## **CANAL SUBDIVISION**

***Revised for the November 19<sup>th</sup> meeting:***

APPLICATION NUMBER 1 DATE November 19, 2009

# DETAIL SITE PLAN

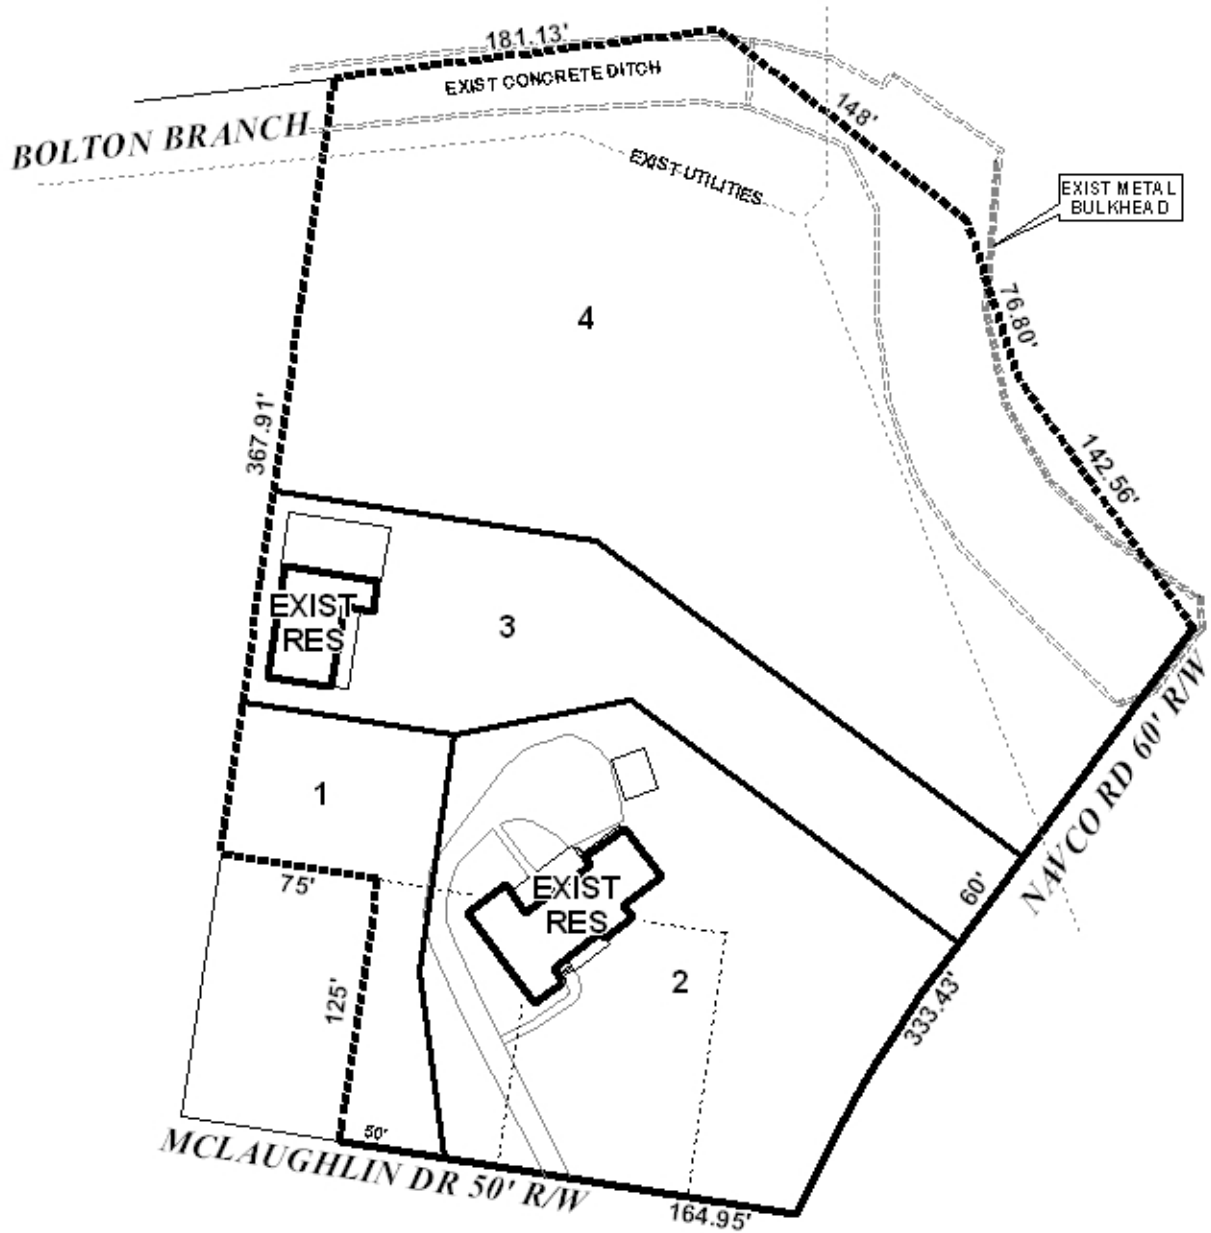
With regard to the configuration of the proposed lots, Lot 1 would be a flag lot. Section V.D.1. of the Subdivision Regulations states “Panhandle or flag lots shall generally not be allowed, but may be permitted only in those locations where varied and irregularly-shaped lot designs are common and the informality of design is consistent with other lots in the vicinity; or, where unusual circumstances such as an odd shaped lot exists; or, separate disparate uses exist on a single lot; or, where there are natural or pre-existing man-made barriers which may cause an undue hardship on the land owner; or in the case of a family division. Requests for panhandle or flag lots shall be accompanied by evidence showing that each panhandle or flag lot is necessary to allow the site owner reasonable use of the site or to alleviate a situation that would otherwise cause extreme hardship.” No justification for the flag lot has been presented by the applicant and the surrounding residential neighborhoods do not contain flag lots. Therefore, the proposed lot would be out of character with the existing configurations in the neighborhood.

Proposed Lot 3 would exceed the maximum 3.5 depth-to-width ratio of Section V.D.3. of the Subdivision Regulations and would be of irregular shape. As there are no other similar recorded lots within the surrounding residential neighborhood, proposed Lot 3 would also be out of character with existing lot configurations. Due to its location in relation to Lot 4 and the drainage canal, with modifications Lot 3 could be made a viable lot if 60' of frontage were to be provided along Navco Road.

*This application was heldover from the October 15<sup>th</sup> meeting at the applicant's request to allow a revised plat and written justification for flag-shaped lots to be submitted to staff. A revised plat was submitted expanding the street frontage of Lot 3 from 50' to 60', but with no changes to Lot 1. Also, a tax map was submitted indicating three "flag lots" in close proximity to the proposed subdivision as justification for the proposed "flag" lot. Two of those are commercial properties across Navco Road just South of the subject site. The third is adjacent on the West side of the subject property and consists of a recorded lot of McLaughlin's 1<sup>st</sup> Addition to Navco Subdivision and two parceled "finger" portions of the undeveloped property North of the recorded lots of that subdivision and South of the Bolton Branch drainage canal. This area was never officially subdivided or indicated as any future development for any subdivision. As these metes-and-bounds "fingers" were created after the official platting of McLaughlin's 1<sup>st</sup> Addition to Navco Subdivision and were never officially resubdivided into existing recorded lots of that subdivision, they should not be considered as justification to allow a "flag lot" within this subdivision. Only "flag lots" created via the official subdivision process after the 1952 adoption of the Subdivision Regulations should be considered as legitimate examples for justification. Also, the near-by commercial "flag lots" should not be considered as justification to allow residential "flag lots".*

*As proposed Lot 3 now has expanded street frontage to 60', it could be considered as a viable lot with a waiver of Section V.D.3. of the Subdivision Regulations due to its depth-to-width ratio. With the elimination of the "flag lot" (Lot 1), the plat could be considered for approval as a three-lot subdivision. However, as the revised plat still contains the "flag lot" and justification for such has not been acceptable to staff, approval as a four-lot subdivision cannot be recommended.*

- 1) Lot 1 does not meet the criteria to justify its flag lot shape and would be out of character with the existing residential lot configurations in the surrounding residential neighborhood; and*
- 2) existing commercial "flag lot" lot configurations within the area should not be considered as justification for residential "flag lot" approvals.*
